LINN OPERATING, LLC IS RESPECTFULLY SUBMITTING A PROPOSED PLUG AND ABANDONMENT PROCEDURE FOR THE MCCLAY FEDERAL #12 WELL IN EDDY COUNTY, NM

** BLM REVISED ** BLM REVISED ** BLM REVISED ** BLM REVISED ** BLM REVISED **

McClay Federal #12
Eddy County, NM
North Benson Queen Field
API: 30-015-23125

Proposed P&A Procedure

LEASE & WELL NO **McClay Federal #12**
 LOCATION **1980' FSL, 660' FWL of Sec 33, T-18-S, R-30-E**
 FIELD **North Benson Queen Field**

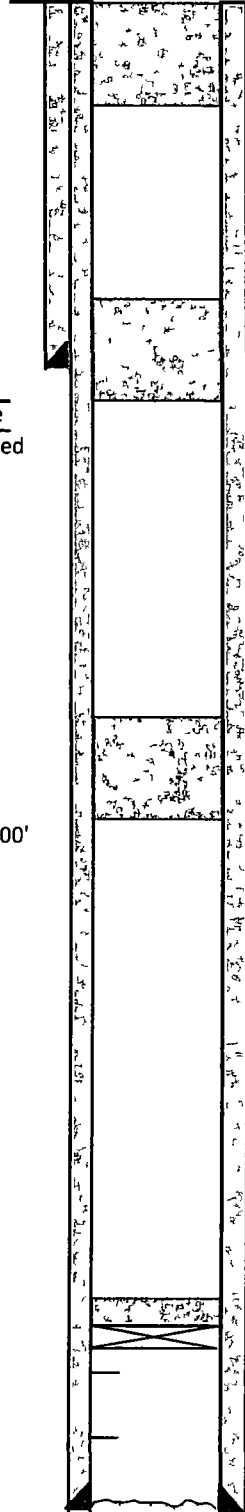
- 1 ~~Place 6 sacks of cement on CIBP at 3169'~~
- 2 Set CIBP at 2800' and place 4 sacks of cement on CIBP *Dump bail 35' cement or spot 25 sx.*
- 3 Pressure test the casing to 500 psi
- 4 Circulate mud laden fluid to surface
- 5 Spot a ~~15~~ sack cement plug from ~~1500' to 1700'~~ *25 sx @ 1520-1320, WOC Tag*
- 6 Spot a ~~15~~ sack cement plug from ~~390' to 590'~~ *25 sx @ 721-595, WOC Tag*
- 7 ~~Spot a 15 sack cement plug from 390' to 590'~~
- 8 Spot a ~~15~~ sack cement plug from 0' to 200' *15 sx (OK)*
- 9 Cut well head off and weld on a dry hole marker

Spot 21 sx plug at 200'
200' cement plug at 0' to 200'

Spot 21 sx plug at 550'
200' cement plug at 550' to 750'

Spot 21 sx plug at 1700'
200' cement plug at 1500' to 1700'

CIBP at 2800' with 6 sx of Cement
